AMDT to OL/Change to Tech Specs: Consisting
of revisions with regard to miscellaneous
topics with the intent to update & improve
existing tech specs.....

Re: Oconee Nuclear Station
Docket Nos. 50-269, -270, -287

Pursuant to 10CFR50, §50.90, an amendment to the Oconee Nuclear Station Technical Specifications, Appendix A to Facility Operating Licenses DPR-38, -27, and -55 is requested. These proposed changes concern several miscellaneous topics and are intended to update and improve the Oconee Technical Specifications. Replacement pages for these proposed changes are attached.

OCONEE NUCLEAR STATION
STATION ORGANIZATION CHART
FIGURE 6.1-1

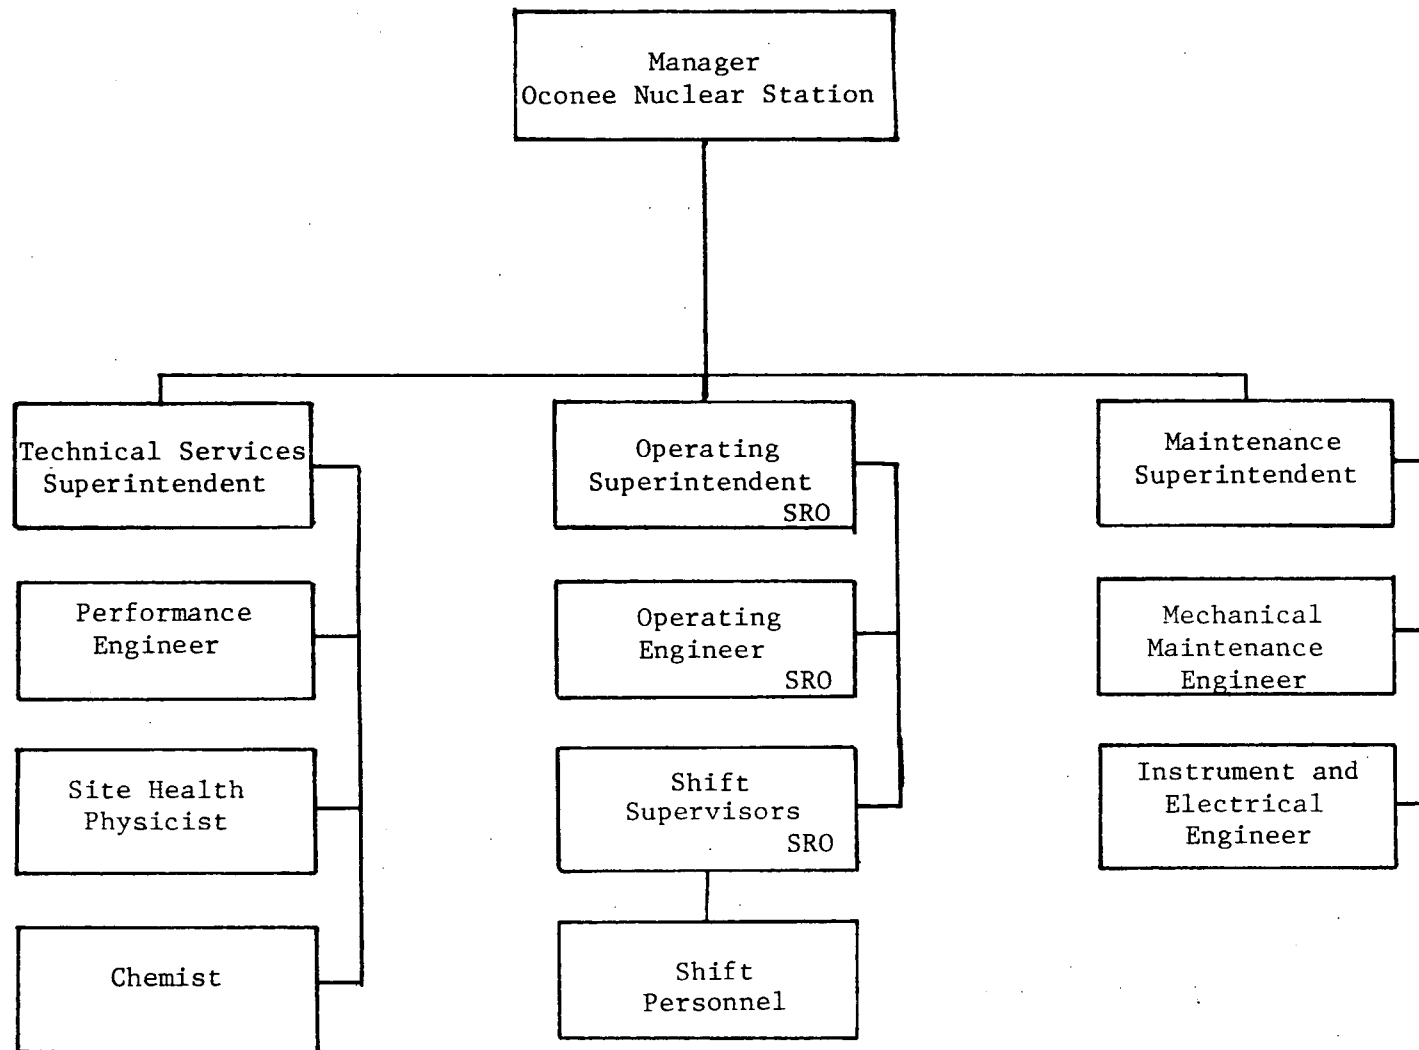
6. Technical Specifications 3.5.2.7, Table 4.11-1, 6.4.1, 6.5.2 and Figure 6.1-1 have been revised as indicated to reflect recent administrative changes and are self explanatory.
